# **NPP FENNOVOIMA (HANHIKIVI 1)**

## **Expert Statement to the EIA Program**

By Order of the  
Federal Ministry for Agriculture, Forestry,  
Environment and Water Management,  
Project Management Department V/6  
“Nuclear Coordination”  
GZ MBLFUW-UW.1.1.2/0006-V/6/2013  
and the Government of Lower Austria

Figure 1: VVER Technology Evolution

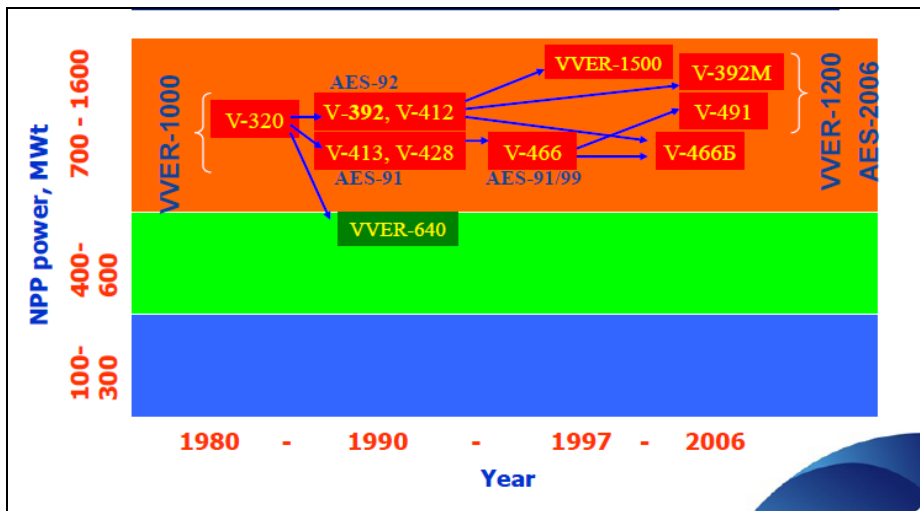
Two variants of the AES-2006 have been developed (see figure 1): Passive safety systems prevail in the type VVER-1200/V-392M, whereas the type VVER-1200/V-491 focuses more on active systems (UMWELTBUNDESAMT 2009b). The EIA program does not mention which variant is chosen for Hanhikivi 1. **It is recommended to explain which variant of the AES-2006 is chosen as well as the reason for this choice.**
